**STAFF REPORT:** 4/14/2021 MEETING

**APPLICATION NUMBER:** 21-7172

**ADDRESS:** 791 SEMINOLE

**SCOPE:** REHABILITATE HOME; REPLACE WINDOWS & REPIAR AND REPLCE SIDING AND TRIM

All exterior stucco and mesh to be removed.  
All uncovered existing wood trim will be retained  
and repaired with like raft & design where req'd.  
All decorative wood trim currently visible will be  
retained and repaired with like raft & design where  
req'd.

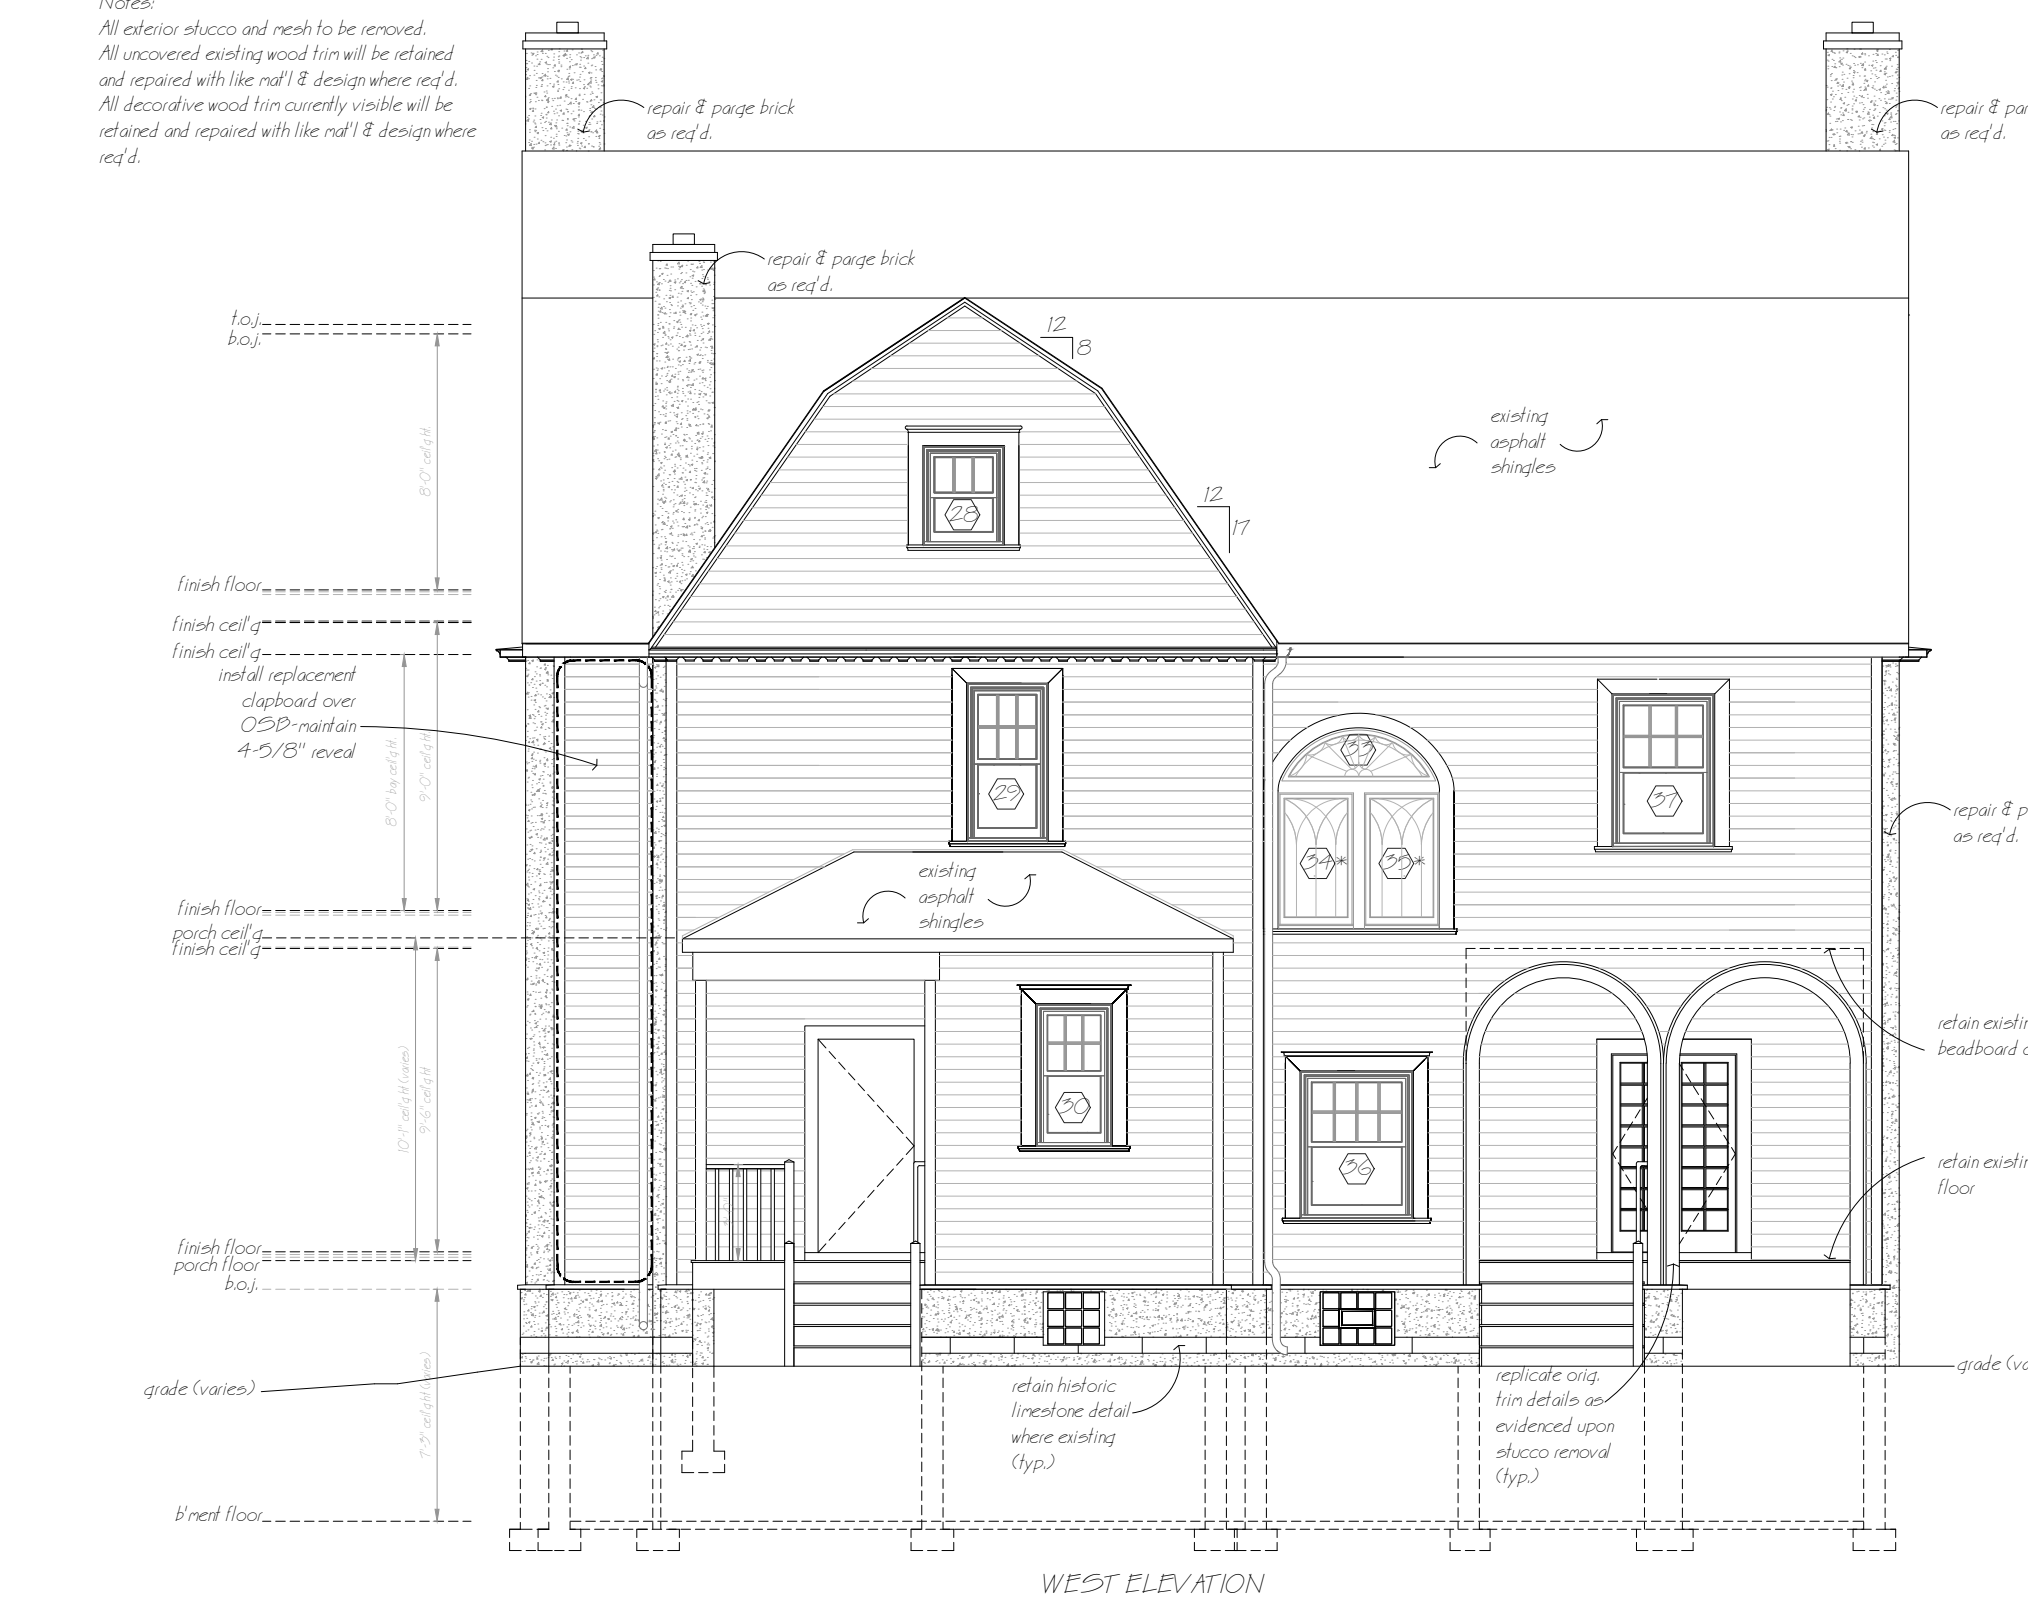
- The project's final construction drawings shall be revised to clearly delineate all extant exterior elements which shall be retained and repaired and the final design of the two rear porches. The revised/final drawings shall be submitted to HDC staff for review and approval prior to the issuance of the project permit
- All proposed new fencing shall be stained or painted a color which complements the home on or before April 14, 2022. The applicant shall provide a final painting proposal to HDC for review and approval prior to the issuance of the project's permit.
